**RE: Potter Valley Hydroelectric Project, FERC No. 77-CA
2023 Flow Variance Request Due to Limited Storage Capacity**

| 2023 Flow Variance Request Due to Limited Storage Capacity Comment Response Matrix | | | | | |

Figure 2. Lake Pillsbury daily storage forecast with variance conditions in effect (assuming July 1st start date). Storage forecast curves assume 2023 block water releases of 2,500 AF on 6/15 and Water Year 2024 block water release of 2,500 AF on 12/1.

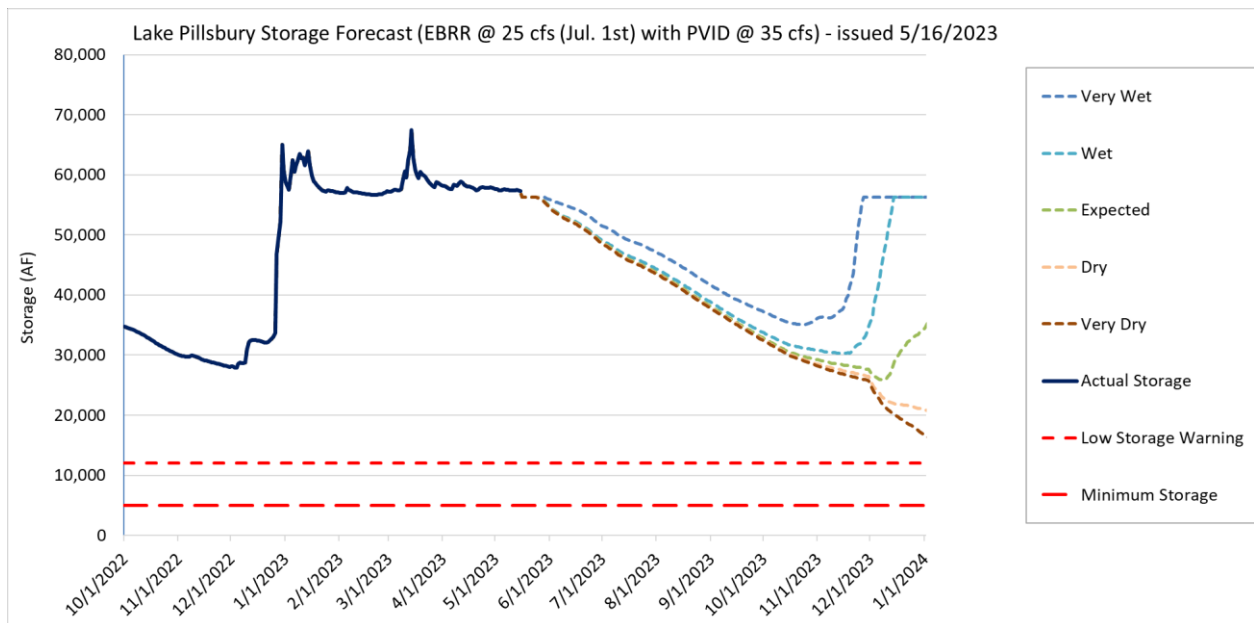
| # | Location | | Comment | Reviewer | Response |
|----|----------|-------------------|--|---------------|---|
| 7 | 4 | Proposed Variance | Should add a project variance storage figure based on max release under variance flow prescriptions, etc.. | NMFS | Agreed, figure 2 added to page 5 |

Commented [JAF9]: Should add a project variance storage figure based on max release under variance flow prescriptions, etc..

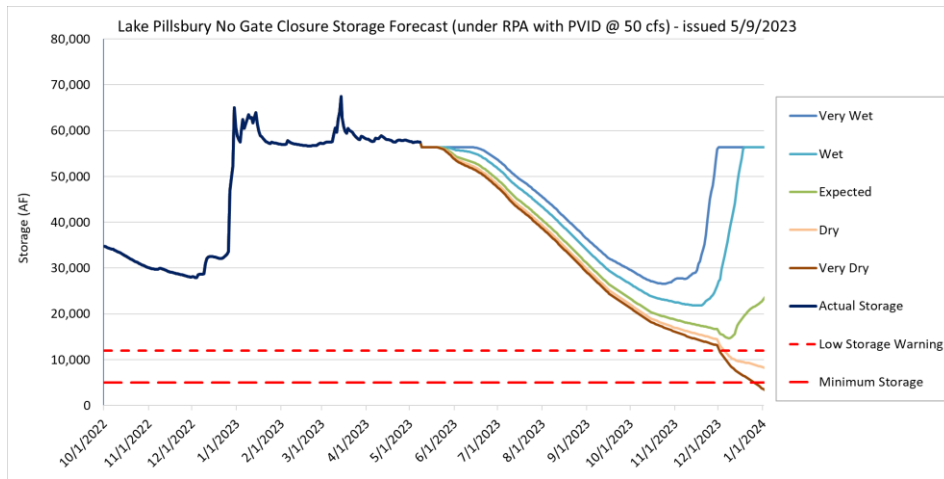
Commented [SM2]: This term should line up with the legend text below to avoid confusion, and to be consistent throughout document

Figure 2.1 Water temperature regime at E2 May through Sept (2010 to 2022)

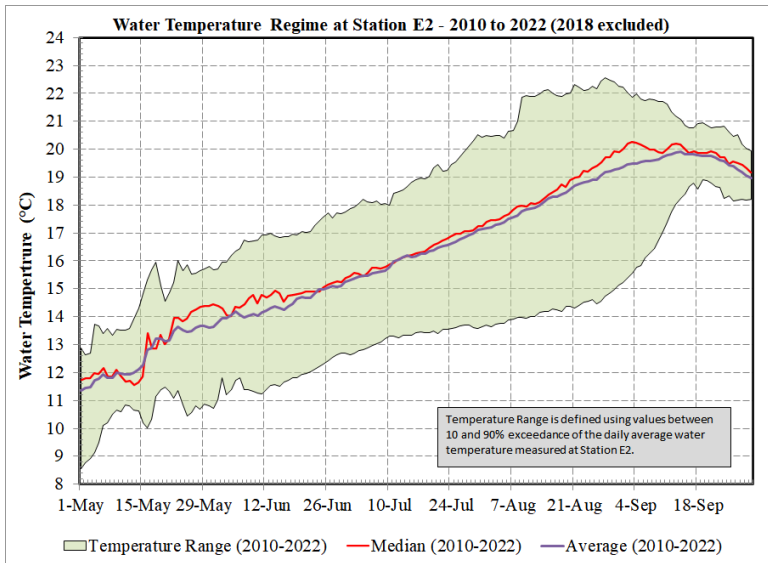
Commented [SM22]: As I mentioned yesterday, this could happen in early June based on the range shown on Figure 2. Added text to clarify
